UNITED STATES PATENT AND TRADEMARK OFFICE

APPLICATION NO.	FILING DATE	FIRST NAMED INVENTOR	ATTORNEY DOCKET NO.	CONFIRMATION NO.
10/596,054	05/26/2006	Rainer Breitenbach	INA-40	1220
20311 7590 05/07/2009 LUCAS & MERCANTI, LLP 475 PARK AVENUE SOUTH 15TH FLOOR NEW YORK, NY 10016				
EXAMINER				
GARCIA, ERNESTO				
ART UNIT		PAPER NUMBER		
3679				
MAIL DATE		DELIVERY MODE		
05/07/2009		PAPER

Office Action Summary

DETAILED ACTION

FIG. 5

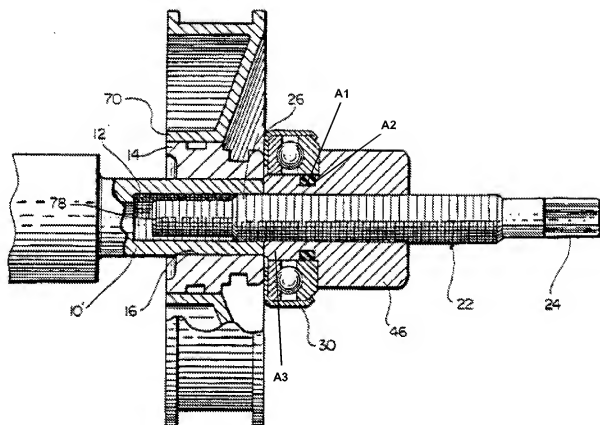
Regarding claim 15, Nelsen et al. disclose, in Figure 5, a screwed joint comprising a flange **14**, a drive element **10'**, a nut **46**, and a bolt **22**. The bolt **22** is on the drive element **10'**. The drive element **10'** and the flange **14** are screwed together at least by the nut **46** and the bolt **22**. The nut **46** has an undercut **A1** (the groove; see marked-up attachment) at least on a portion of the nut **46** from a direction of the flange **14**. The portion is spaced axially in relation to the flange **14**. The undercut **A1** (the groove) has a radial wall **A2** (every groove has two radial walls) facing the flange **14**. The nut **46** is extended axially by a shank **A3**.

Regarding claim 16, the undercut **A1** is at least one radial recess **A1**.

Regarding claim 17, the radial recess **A1** is at least one annular groove **A1**.

Regarding claim 18, the bolt **22** has an external thread. The nut **46** has an internal thread corresponding to the external thread (page 5, 2-4). The annular groove **A1** is on an outer side facing away radially from the internal thread (the groove is on the outside of the internal thread).
